Federal Aviation
Administration

Aeronautical Study No.
2018-ANM-720-OE

**** NOTICE OF PRESUMED HAZARD ****

Structure:	LNG Carrier Vessel - Stack, Transit Point 6
Location:	North Bend, OR
Latitude:	43-25-13.85N NAD 83
Longitude:	124-16-09.31W
Heights:	12 feet site elevation (SE) 199 feet above ground level (AGL) 211 feet above mean sea level (AMSL)

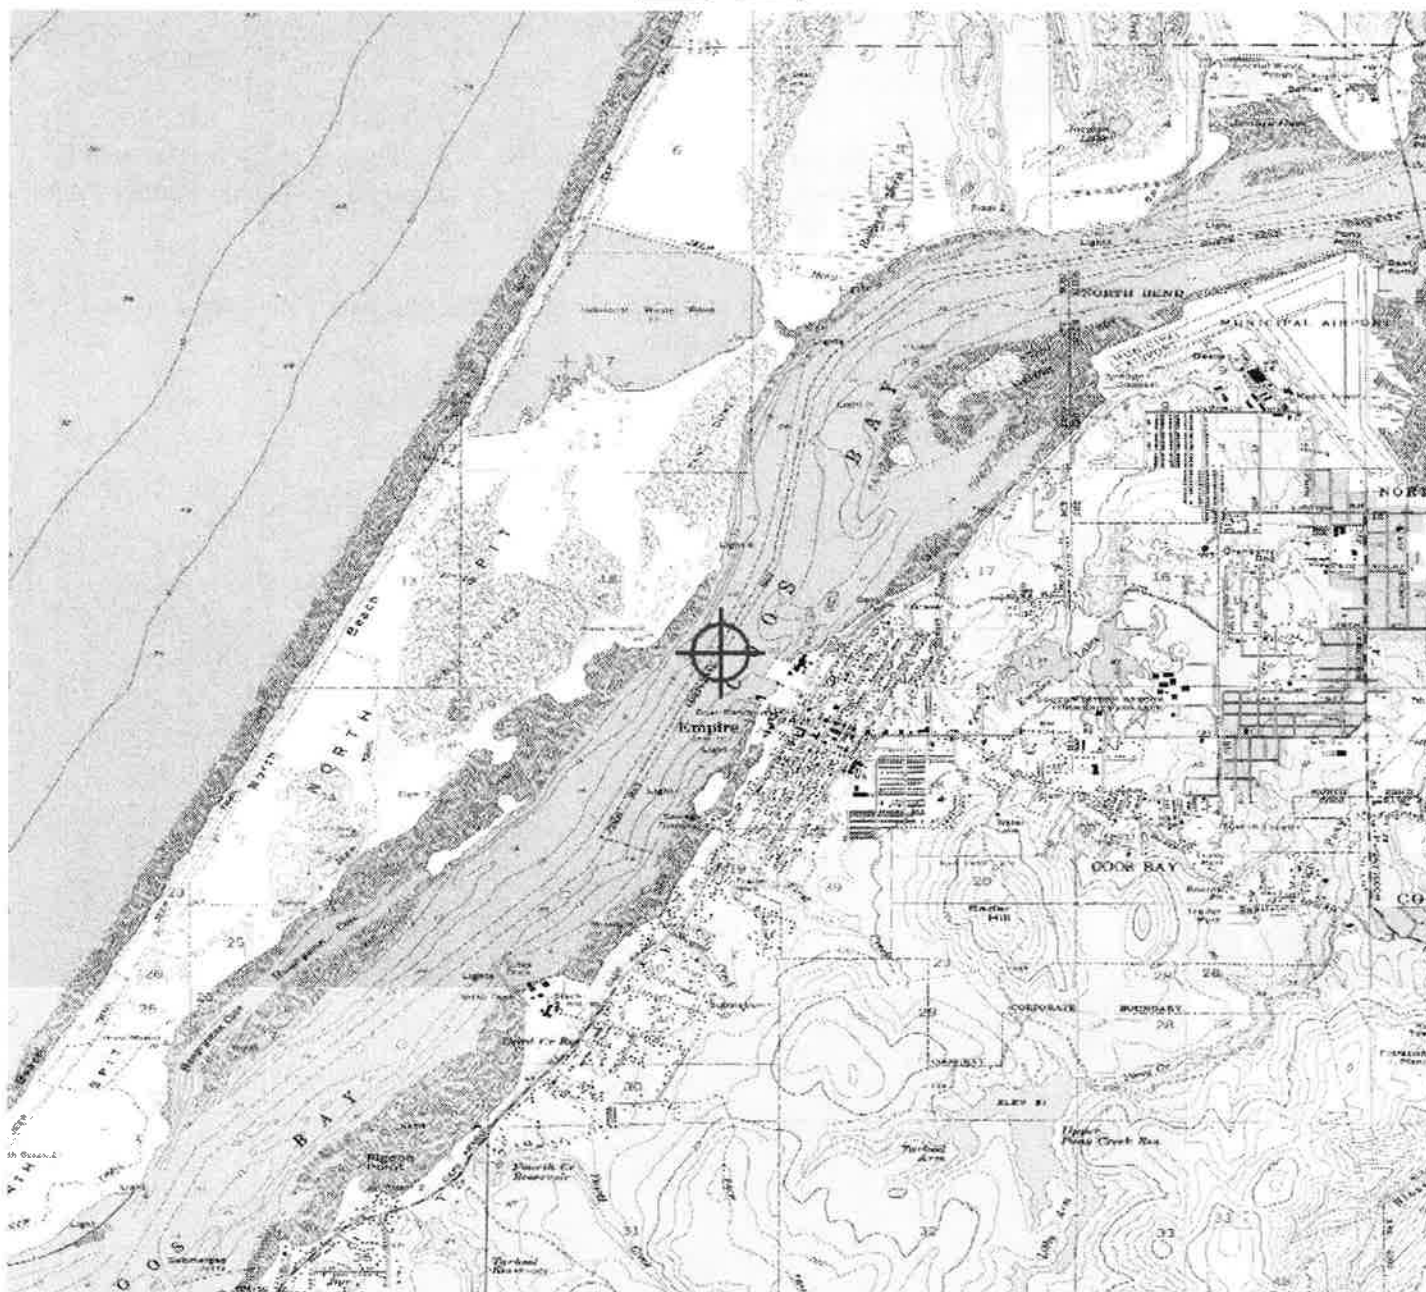
- b. Section 77.19(a): Horizontal Surface-a height exceeding a horizontal plane 150 feet above the established airport elevation. The proposed structure would exceed the OTH Horizontal Surface by 44 feet.

1. You must resolve the 32 foot OTH RWY 4 RNAV (RNP) Z penetration by lowering the structure height, with all appurtenances, to a maximum height at 167 AGL (179 AMSL)

2. If you agree to limit the structure height to 155 feet AGL (167 AMSL), the FAA can then withdraw this objection to the proposed structure as it would not exceed obstruction standards and a favorable determination could be subsequently issued.
3. You can terminate the proposal at this location.
3. You can request further study for any height between 155 AGL and 167 AGL. Further study will include a public notice circularization and 37-day comment period where the outcome cannot be predicted. Further FAA study for any height greater than 167 AGL (179 AMSL) is not an option.

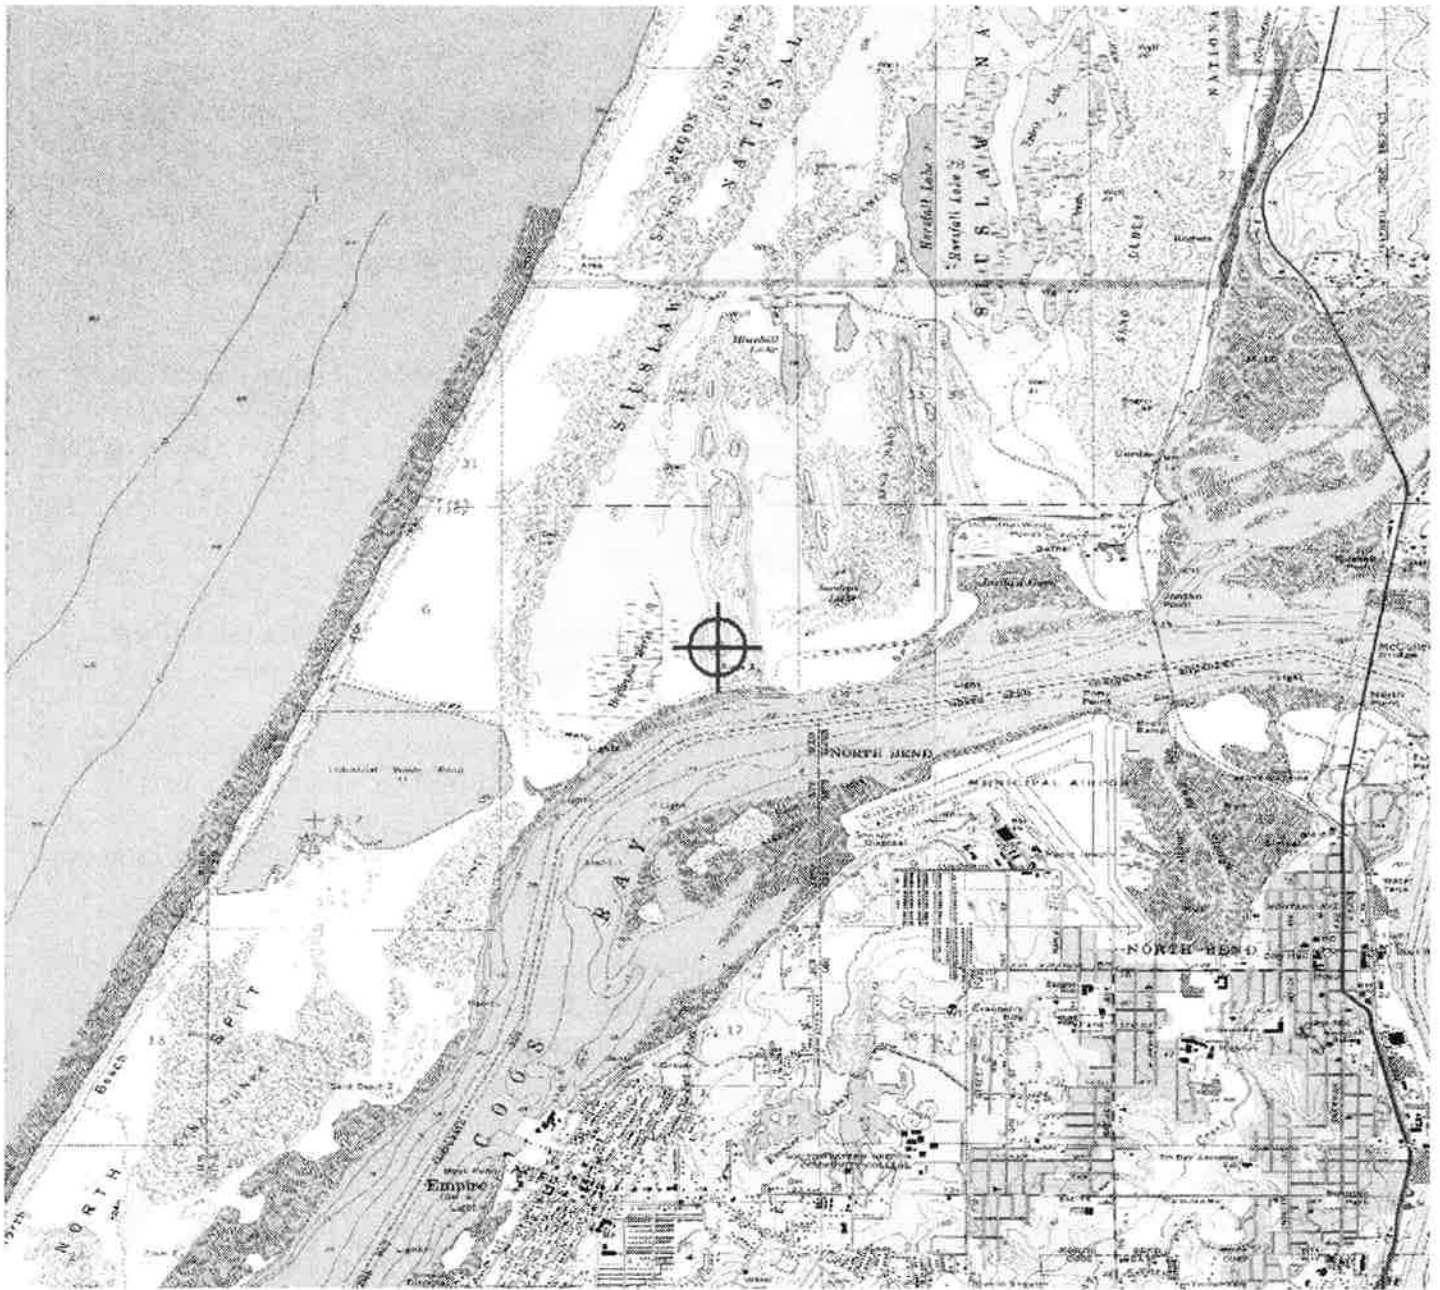
Section 77.19(a): Horizontal Surface-a height exceeding a horizontal plane 150 feet above the established airport elevation. The proposed structure would exceed the OTH Horizontal Surface by 42 feet.

Additionally, the proposed structure would exceed the OTH VFR traffic pattern airspace in the Part 77 VFR Horizontal Surface feet as defined in FAA JO 7400.2L, 6-3-8, Evaluating Effect on VFR Operations.

This proposed structure would exceed the OTH VFR Traffic Pattern Horizontal Surface by 42 feet. The not-to-exceed height of 157 feet AGL (167 AMSL) will avoid penetrating the Horizontal Surface.

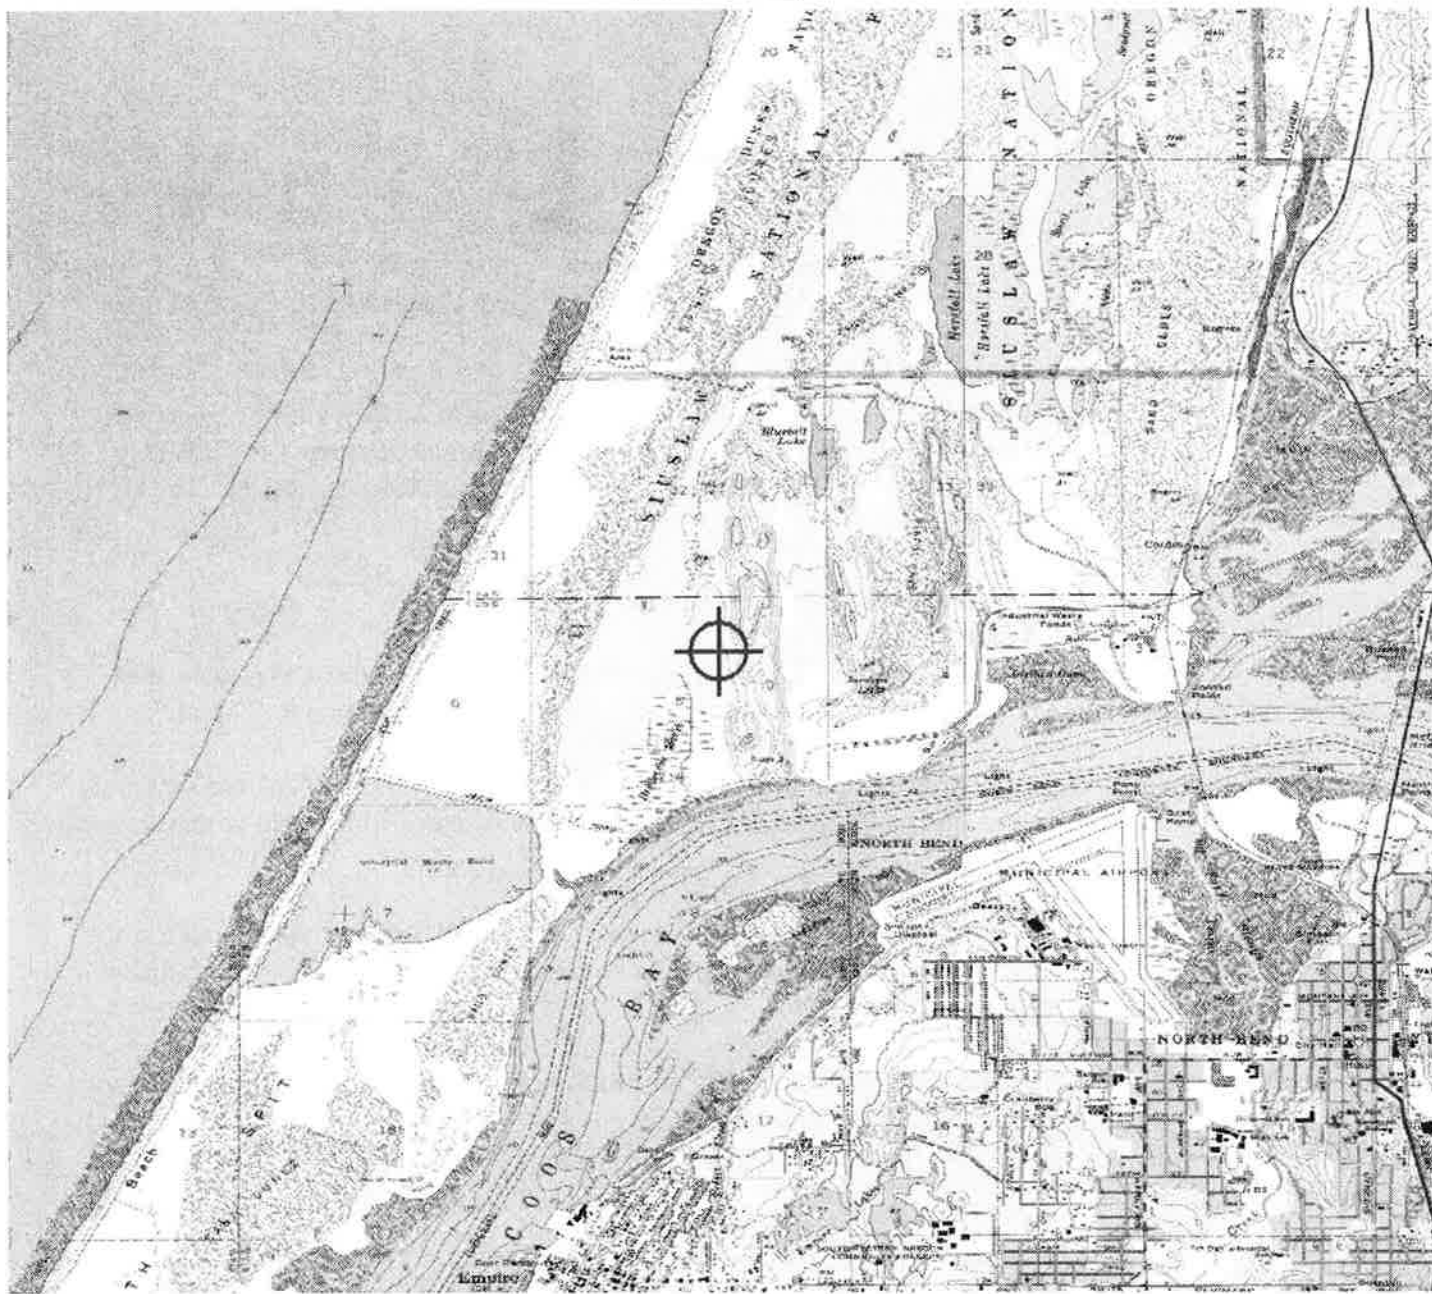
Section 77.19(a): Horizontal Surface-a height exceeding a horizontal plane 150 feet above the established airport elevation. The proposed structure would exceed the OTH Horizontal Surface by one (1) foot.

You also have the option to either terminate the proposal or request further FAA study of the structure at the originally requested height. Further study will include a public notice circularization and 37-day comment period where the outcome cannot be predicted.
